**Further clarification to Queries in Tender no. 02/STS/MDN/UHF/2015-16,  
Dated: 13.05.2015**

This has reference to the pre-bid meeting held in the conference Hall of the office of the ADGP, CL&M on 26.05.2015 and clarification issued to the queries on for Supply, Installation and Maintenance of Digital UHF Wireless Equipments vide Tender notification no. 02/STS/MDN/UHF/2015-16, Dated 26.05.2015

# Block Schematic

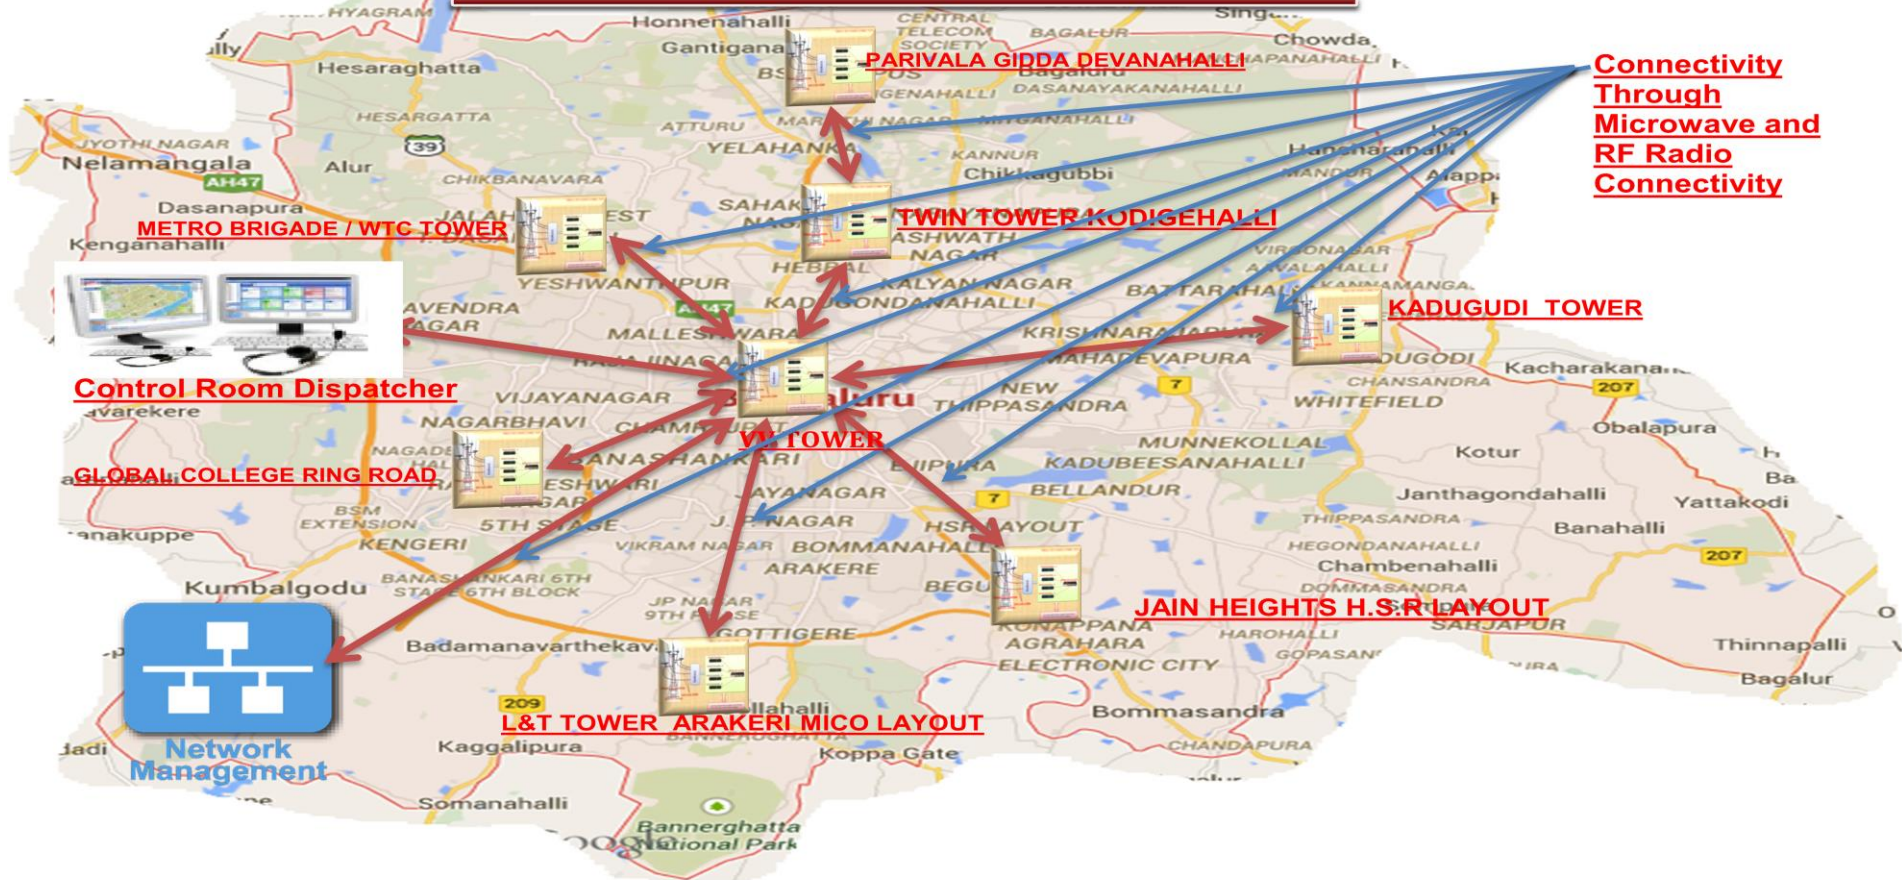
*We request department to provide the total system architecture of the entire project.*

**Clarification:** As per discussion held with the all the vendors participated in the pre-bid meeting on 28.05.2015. The Network system architecture of the entire project and design of Network Management System (NMS) is finalized and the same is enclosed for reference.

As per discussion it was agreed that the Typical Network design should be as per the block diagram enclosed

Also the Network Management system (NMS) design should be inbuilt in the GPS/ AVLS messaging dispatch console having client server architecture and should have the capability (capacity for future requirement i.e., up to 15000 subscriber / users).

The block diagram of the dispatch console with Network Management system (NMS) feature is enclosed for reference.
